SUBJECT: Preliminary Plat of Falcon Lookout Ph. 2 at 1000 N. Falconcrest Dr. (S-142-07)

S-142-07 – Conditions for Preliminary Plat – 1000 N. Falconcrest Dr (Falcon Lookout Phase 2)

SUBJECT: Request from Larry and Susan Pew for Preliminary Plat approval of Falcon Lookout Phase 2, a 23 lot and 1 tract residential subdivision located on 16.55 acres at 1000 N. Falconcrest Drive, a portion of Assessor Parcel Number 302-23-107A. (S-142-07)

PRELIMINARY PLAT FOR FALCON LOOKOUT PHASE 2

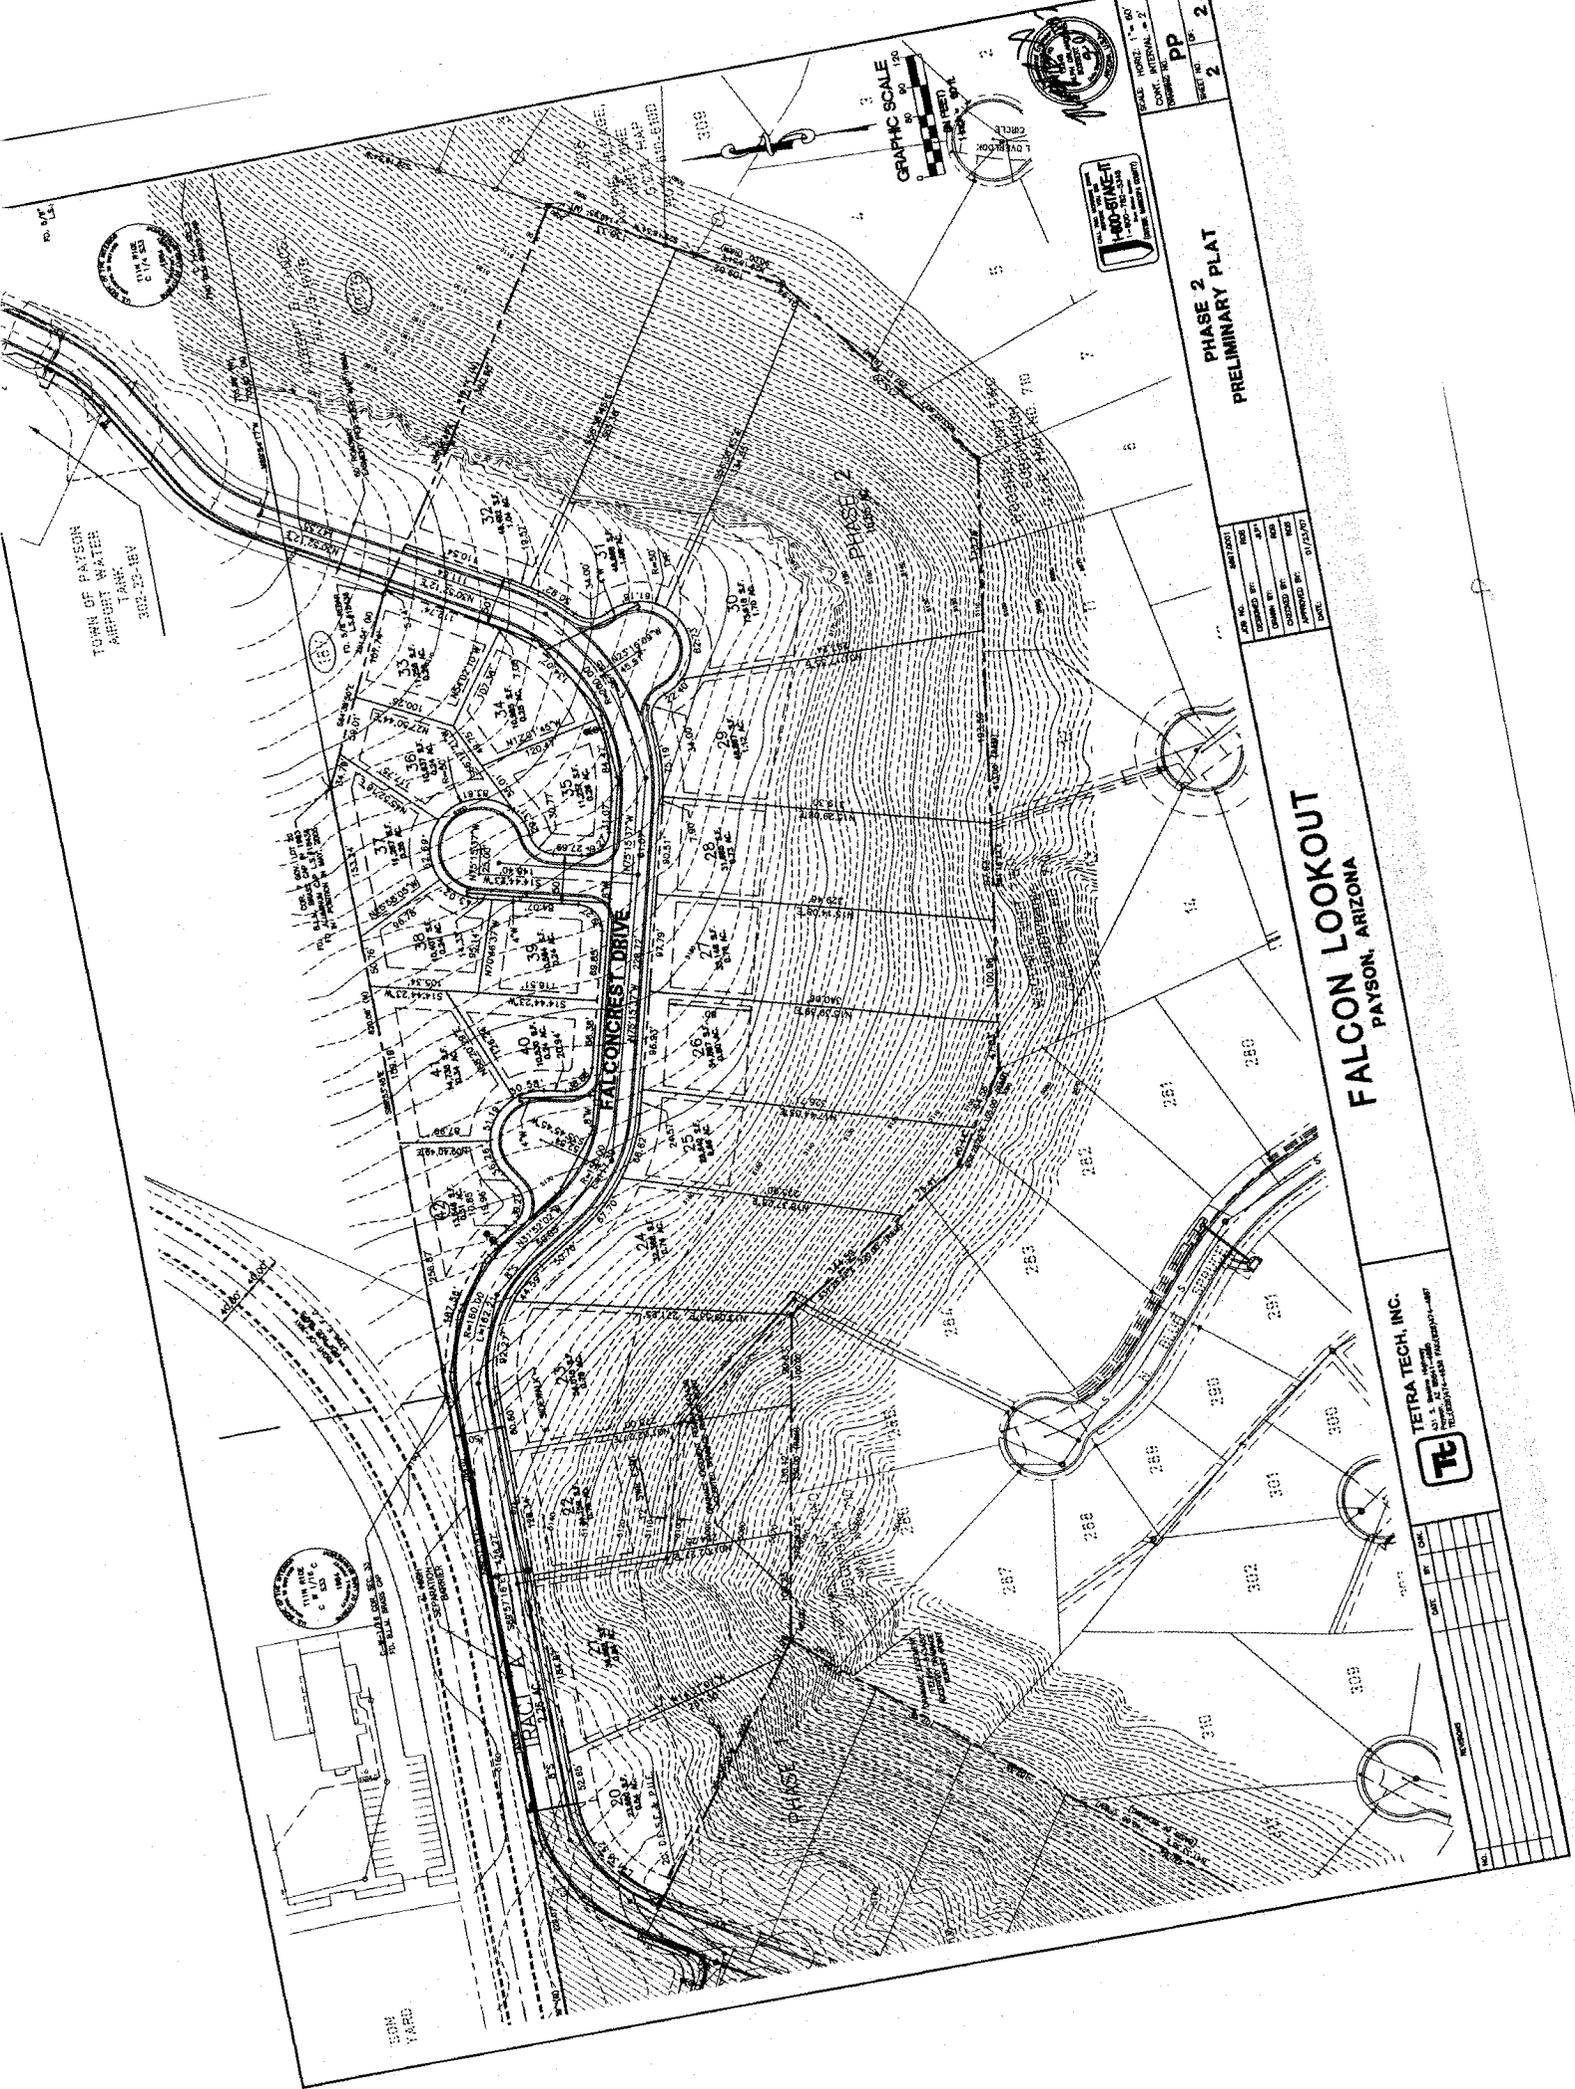
14. The maximum fill slope adjacent to the street is 3:1 and the maximum cut slope adjacent to the street is 2:1. (The detail on the preliminary plat is incorrect.)

15. Revise Note 19 to provide an annual report to Town of Payson "Engineer," not "public Works Director."
16. A screen wall/separation barrier of approved materials shall be constructed (minimum 4' high) wherever the Falconcrest Drive improvements are within 100 feet of the improvements on Airport Road.

14. The maximum fill slope adjacent to the street is 3:1 and the maximum cut slope adjacent to the street is 2:1. (The detail on the preliminary plat is incorrect.)

15. Revise Note 19 to provide an annual report to Town of Payson "Engineer," not "public Works Director."
16. A screen wall/separation barrier of approved materials shall be constructed (minimum 4' high) wherever the Falconcrest Drive improvements are within 100 feet of the improvements on Airport Road.
